January 16, 2011, from W4WWQ

2011 ARRL Handbook error.

Section 24 Station Accessories, Ref. Figure 24.37, page 24.24

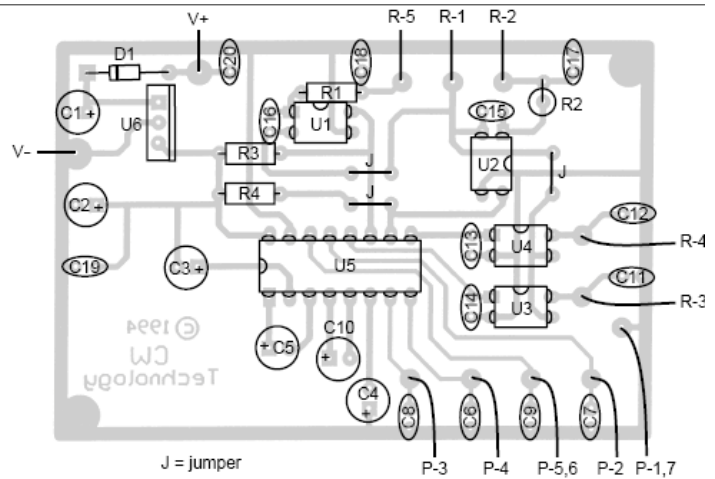
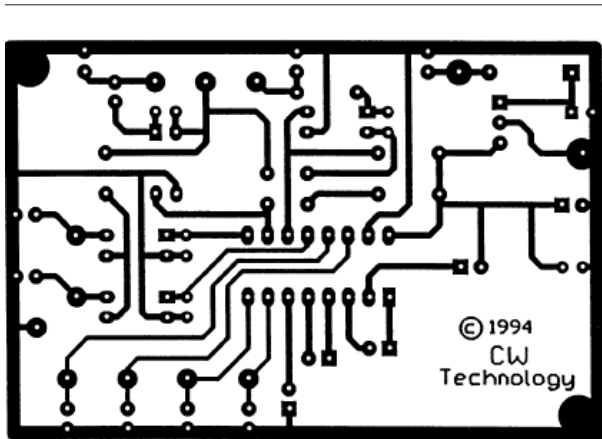
If we assume the schematic diagram is correct with reference to R3 and R4, then the component placement diagram on the CDROM has R3 & R4 shown in reverse locations as shown below.
